# AIA Document G701™ – 2017

## Change Order

**PROJECT:** (Name and address)  
Williamson County  
Animal Shelter Expansion  
1855 SE Inner Loop  
Georgetown, TX 78626

Change Order No. 3 includes the below listed Vaughn Change Proposals # 11-#17. For Vaughn Project No. 2491-01.

**E.2-3.21**

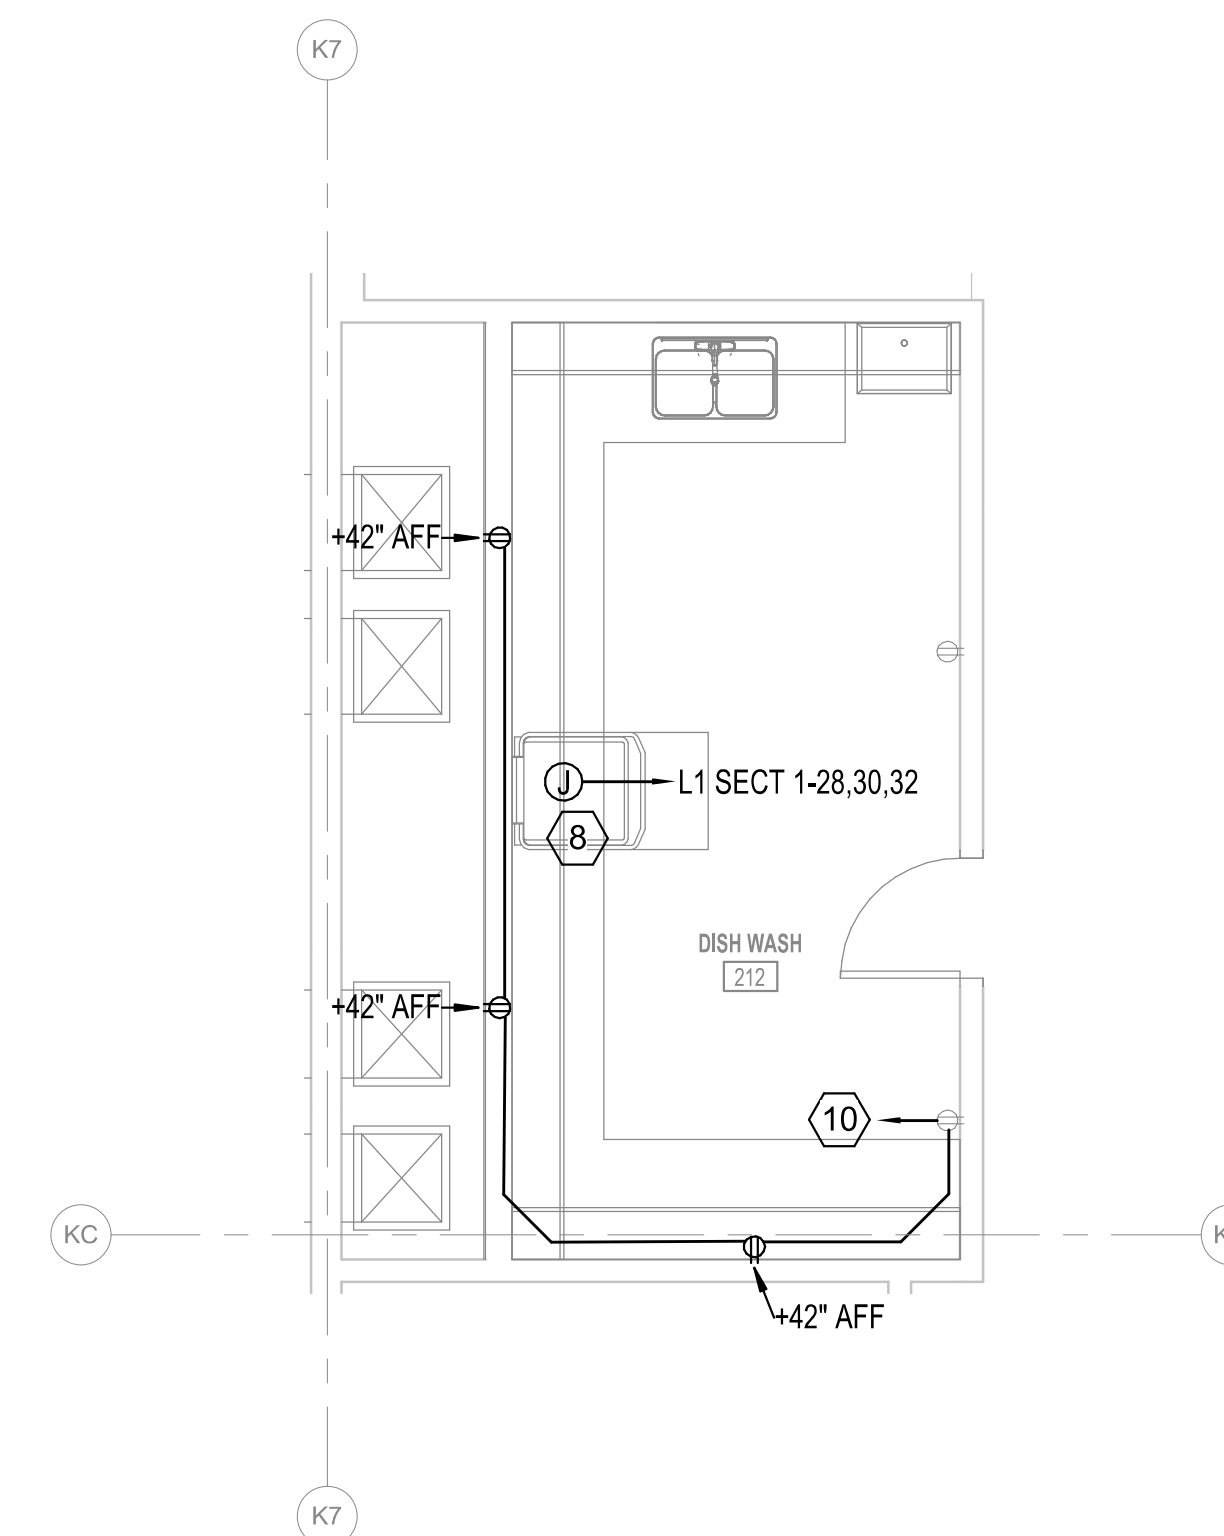
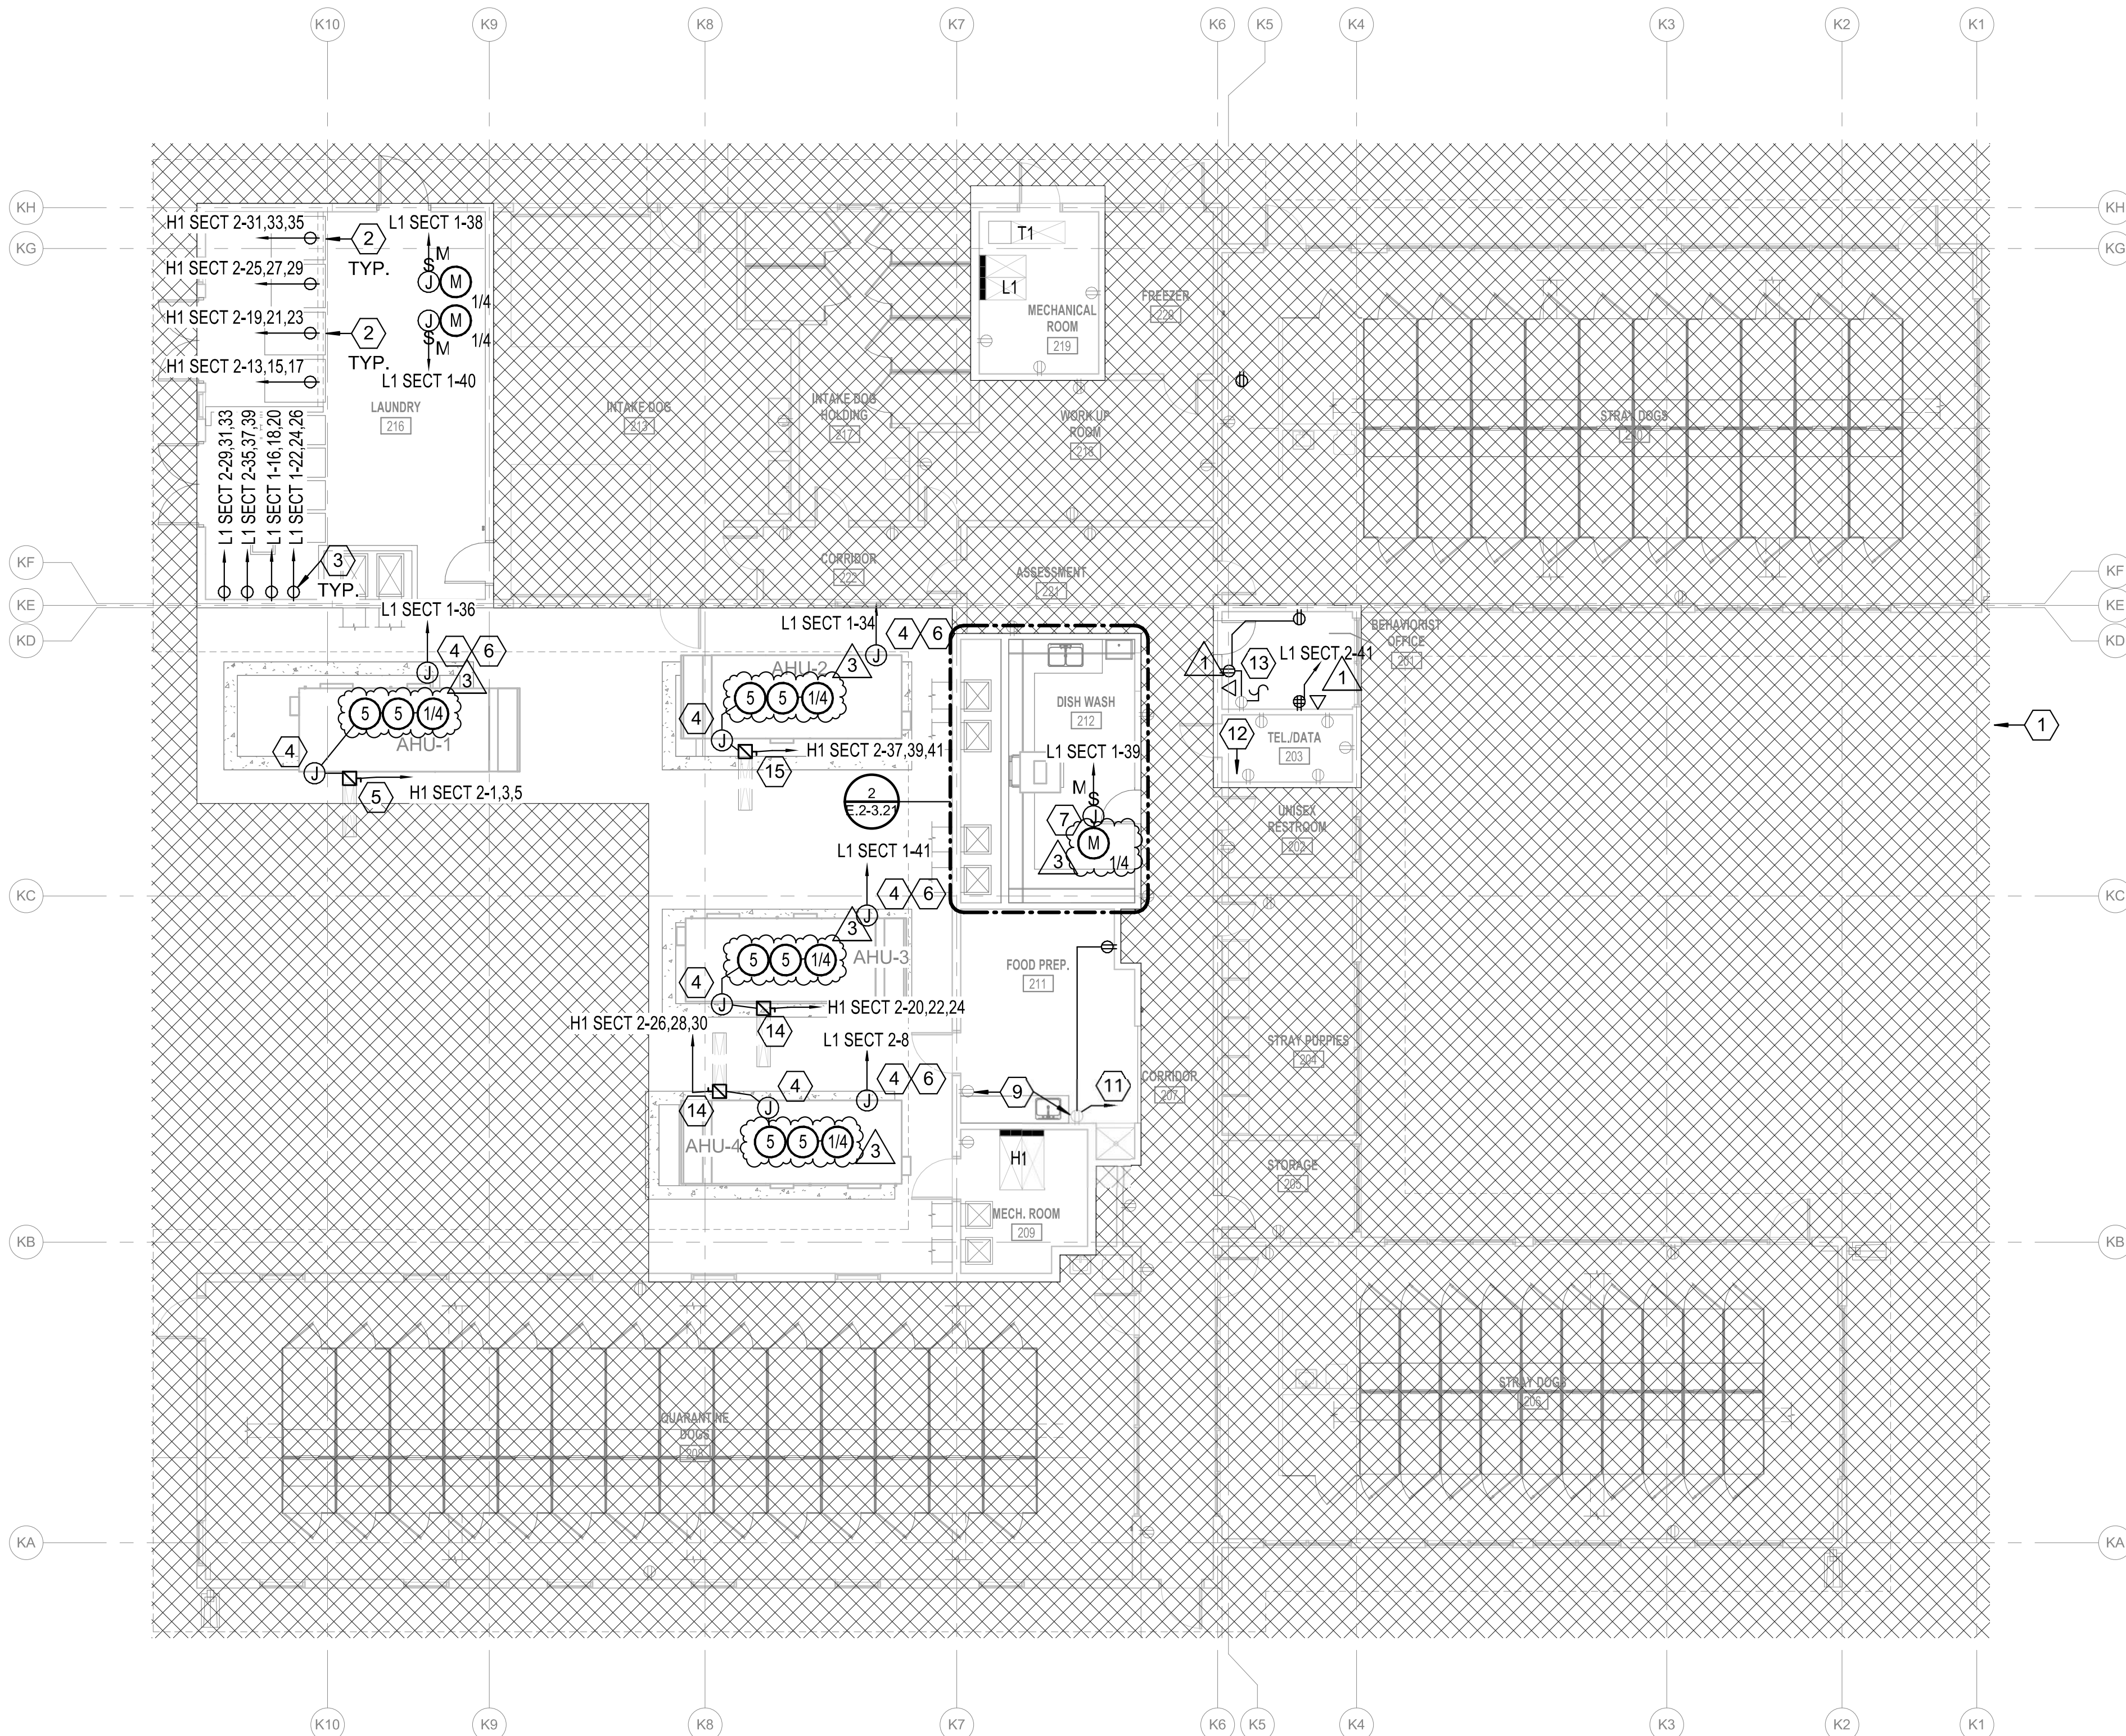
RFI SUBJECT: Possible undersized breakers for AHU's

Please verify breaker sizes.

- PROVIDE NEMA 3R, 60A/3P/600V RATED DISCONNECT FUSED AT 50A. UNISTRUT MOUNT DISCONNECT TO EQUIPMENT PAD. COORDINATE LOCATION WITH DIV 23.
- PROVIDE POWER TO MECHANICAL EQUIPMENT AUXILIARIES (LIGHTING, RECEPTACLES, ETC.)
- PROVIDE POWER TO EXHAUST FAN ON ROOF. COORDINATE EXACT LOCATION WITH DIV 23.
- PROVIDE POWER TO COMMERCIAL DISH WASHER.
- REPLACE RECEPTACLE WITH GFCI-PROTECTED RECEPTACLE.
- CONNECT NEW RECEPTACLES TO EXISTING CIRCUIT SERVING DISHWASH 212.

- CONNECT NEW RECEPTACLES TO EXISTING CIRCUIT SERVING FOOD PREP 211.
- EXTEND EXISTING CONDUIT FROM KENNEL TELECOM ROOM TO NEW ADOPTIONS TELECOM ROOM.
- CONNECT NEW RECEPTACLES TO EXISTING CIRCUIT SERVING ROOM 201.
- PROVIDE NEMA 3R, 60A/3P/600V RATED DISCONNECT FUSED AT 40A. UNISTRUT MOUNT DISCONNECT TO EQUIPMENT PAD. COORDINATE LOCATION WITH DIV 23.
- PROVIDE NEMA 3R, 100A/3P/600V RATED DISCONNECT FUSED AT 70A. UNISTRUT MOUNT DISCONNECT TO EQUIPMENT PAD. COORDINATE LOCATION WITH DIV 23.
